**NSLPP MEETING HELD ON 01/05/24****Attachments:**

ADDRESS/WARD: Unit 9 and 9A, 50 Milson Road, Cremorne Point**APPLICATION NO:** DA353/23**PROPOSAL:** Consolidation of two units, alterations and additions including internal demolition and reconfiguration, landscaping and addition of pergola on existing roof terrace.**PLANS REF:**

OWNER: Robyn Mary Assunta Denholm**APPLICANT:** Robert Furey C/O Walter Barda Design**AUTHOR:** Report of Robin Tse, Senior Assessment Officer**DATE OF REPORT:** 22 April 2024**DATE LODGED:** 15 December 2023**RECOMMENDATION:** Approval

Print Date & Time: 15/12/2023 3:44:42 PM
File Path: Z:\0202_24_Denholm Taylor Penthouse\02 - Architectural Plans\02 DA - Detailed\Appendix 1 - 50 Milson Rd Penthouse.rvt
Drawn By: RF
Checked By: WB
Approved By: WBD
Scale @ A1 As indicated
Drawing Number: **A202**
Issue: **E**

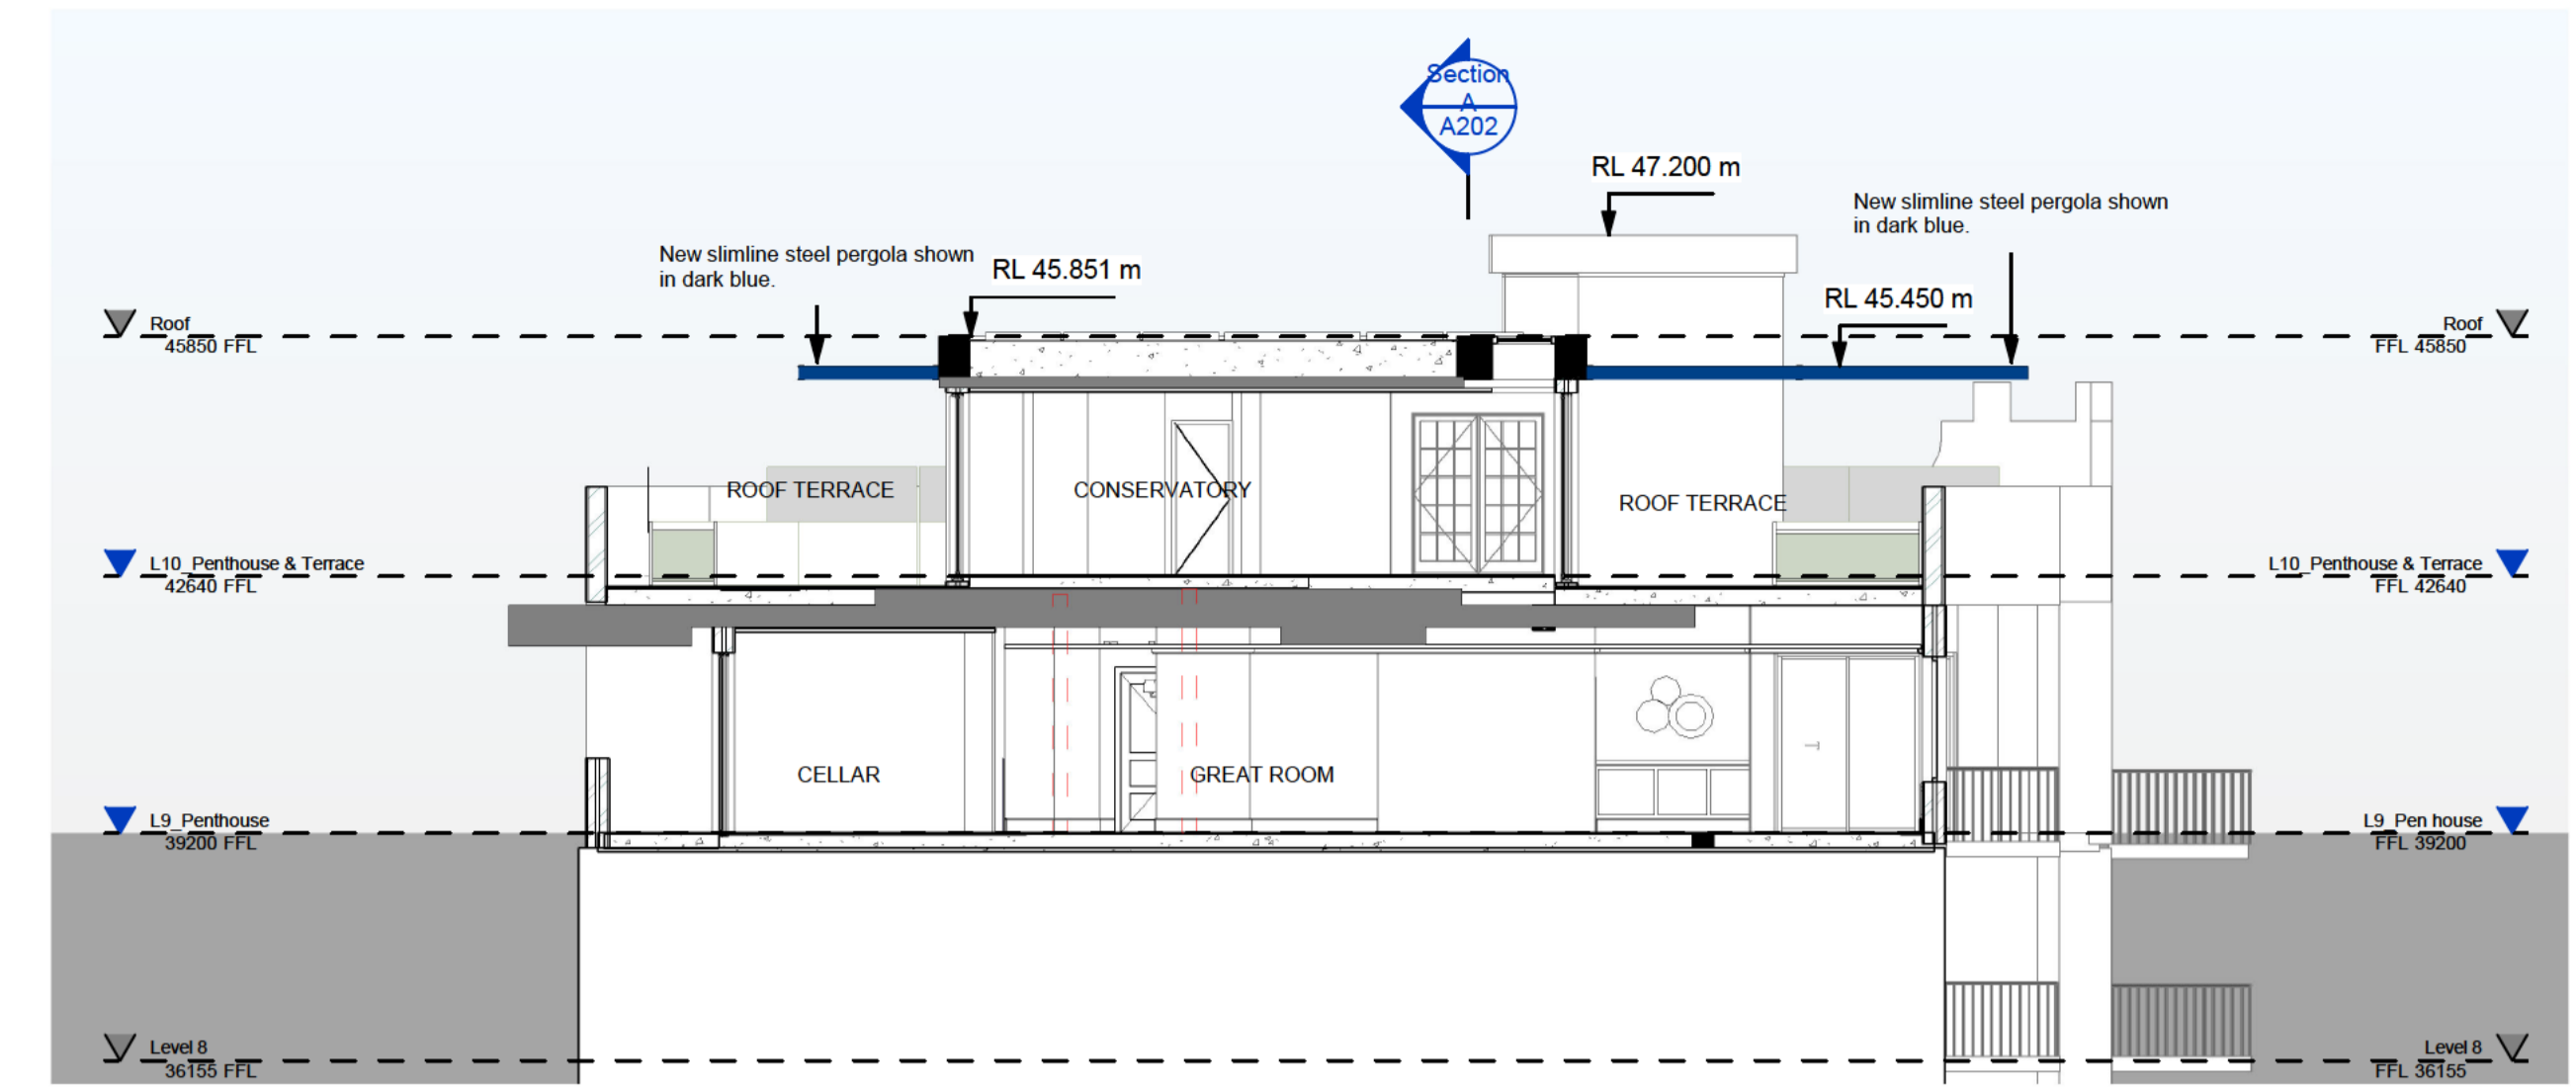
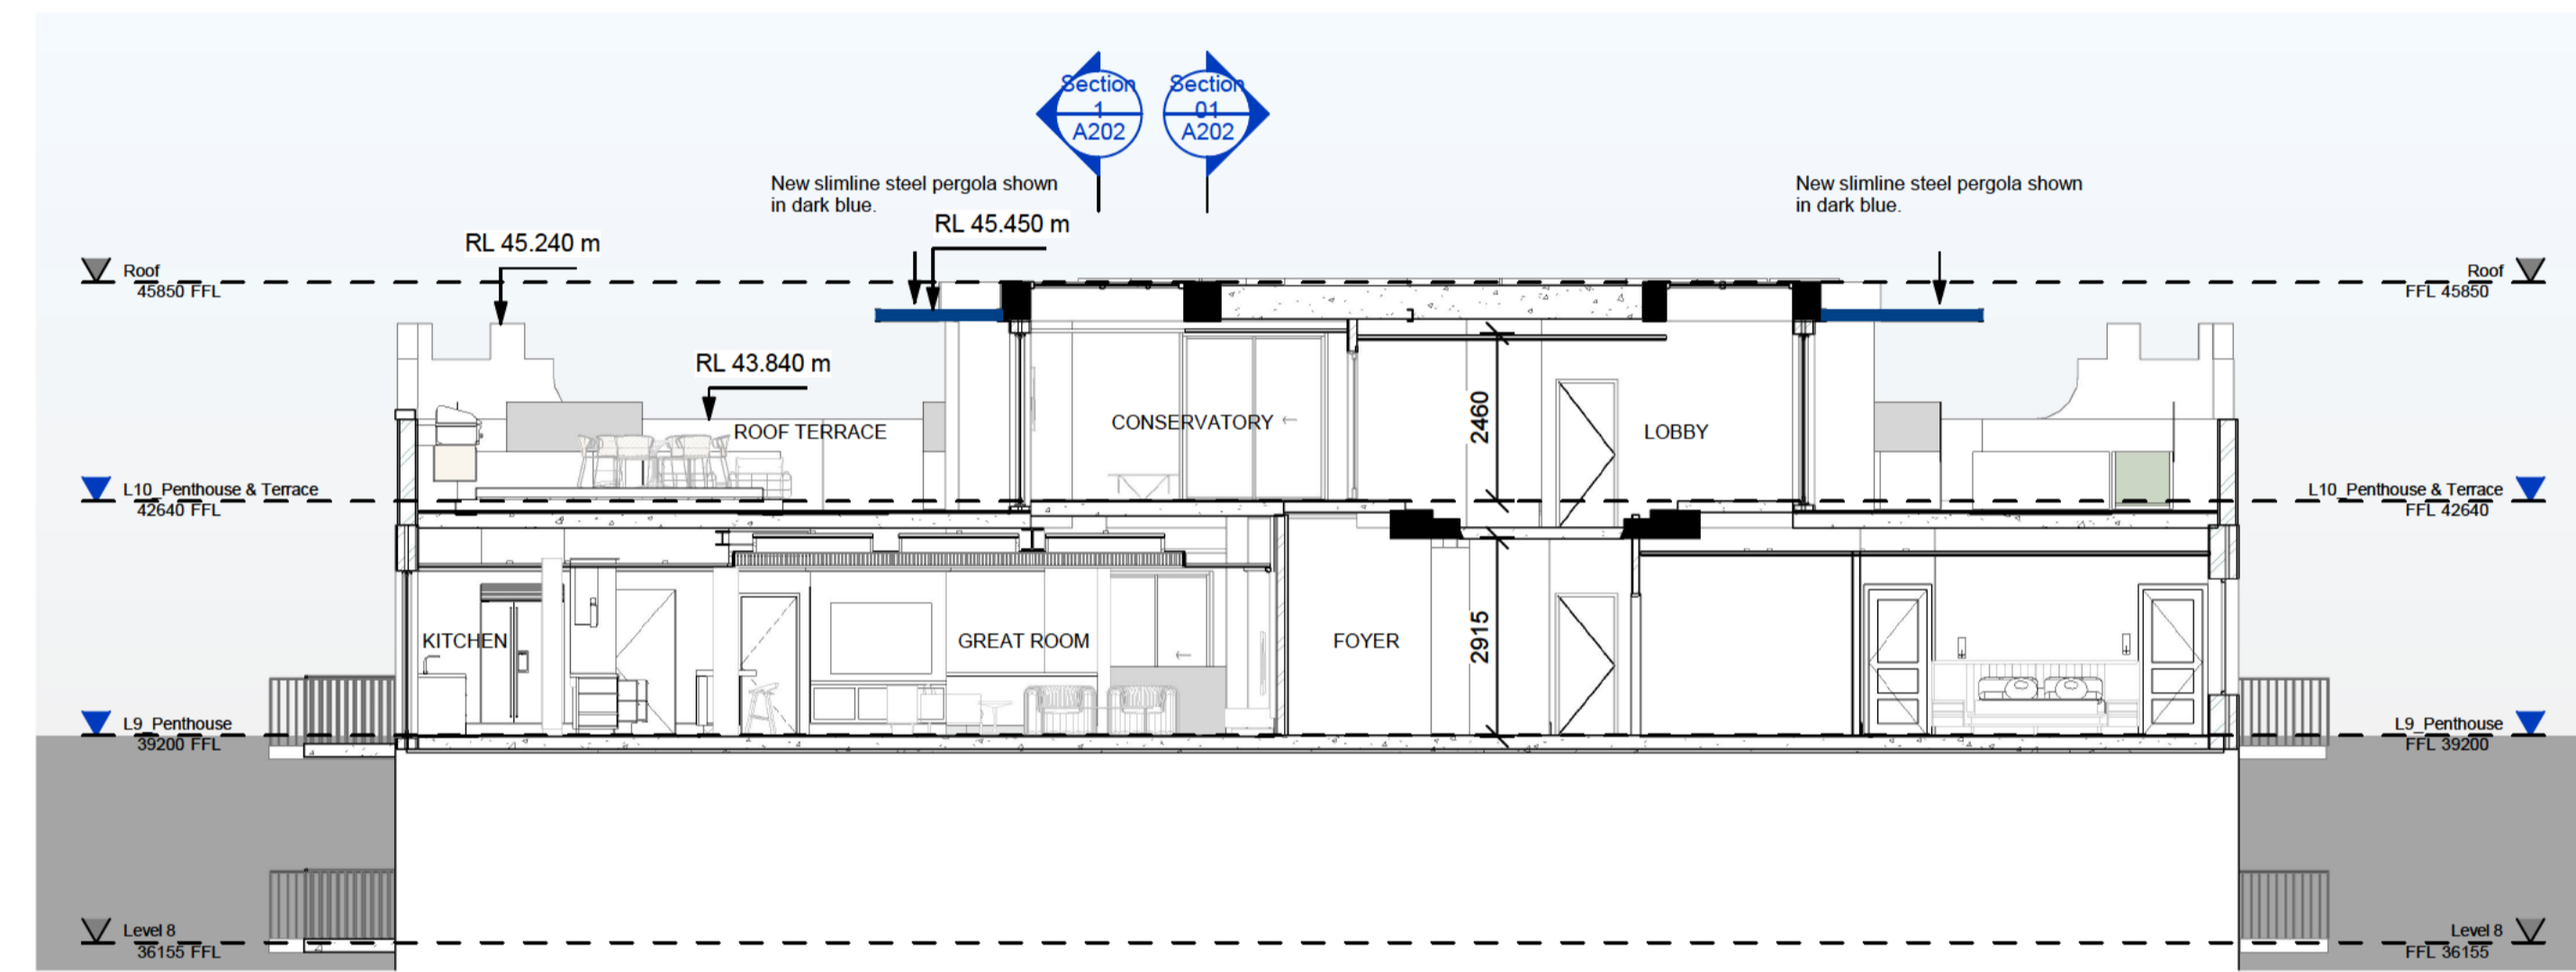
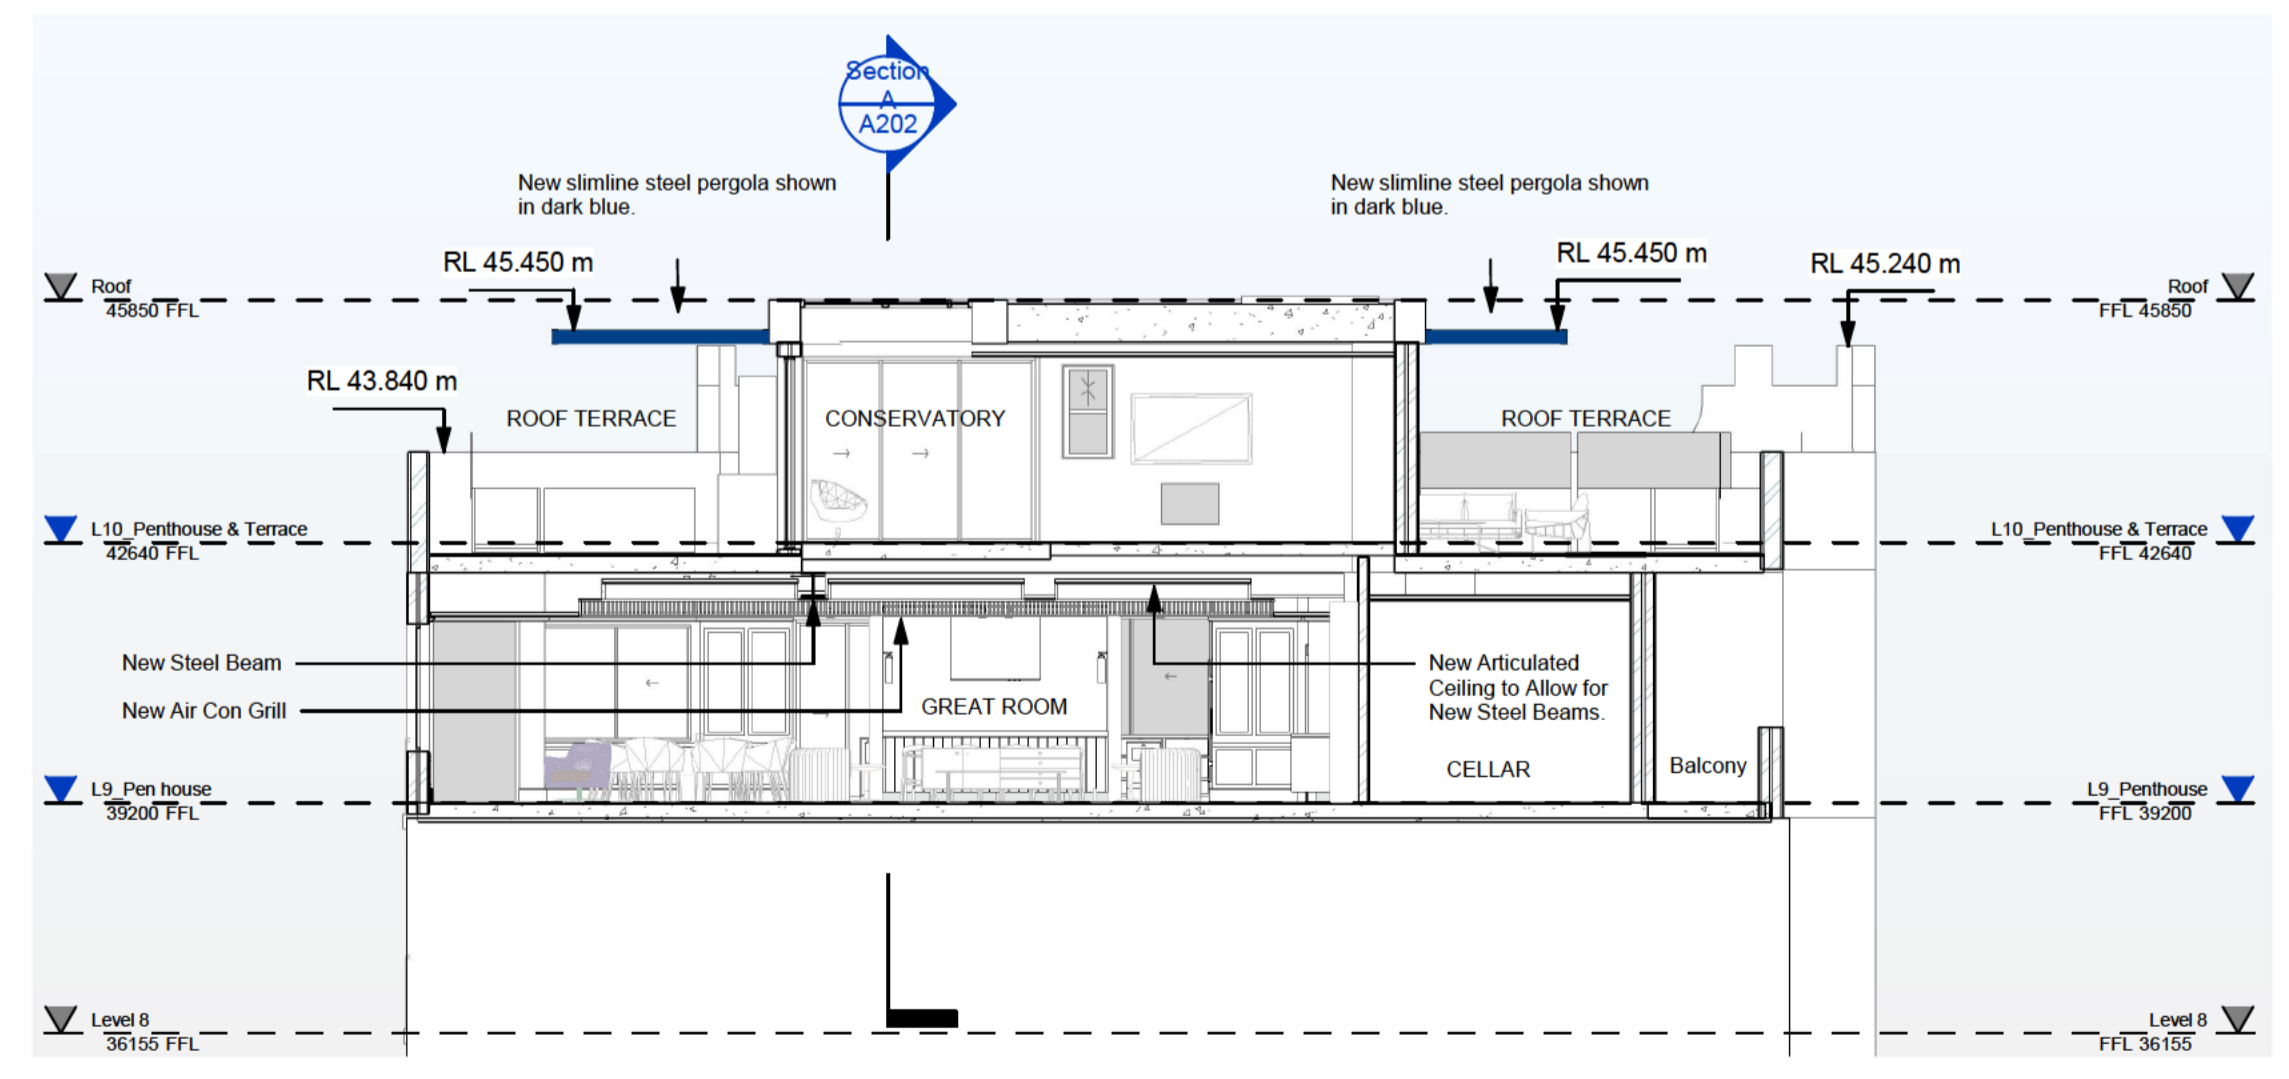
- C2. The following design modifications shall be applied to the proposed development:
- (a) The proposed pergola to the south of the southern building line of the roof level (Level 10) structure containing the conservatory/kitchen/bathroom shall be deleted and form no part of this consent to minimise any impacts on significant views as seen from the neighbouring properties; and
 - (b) The existing flagpole on top of the Level 10 structure shall be removed.
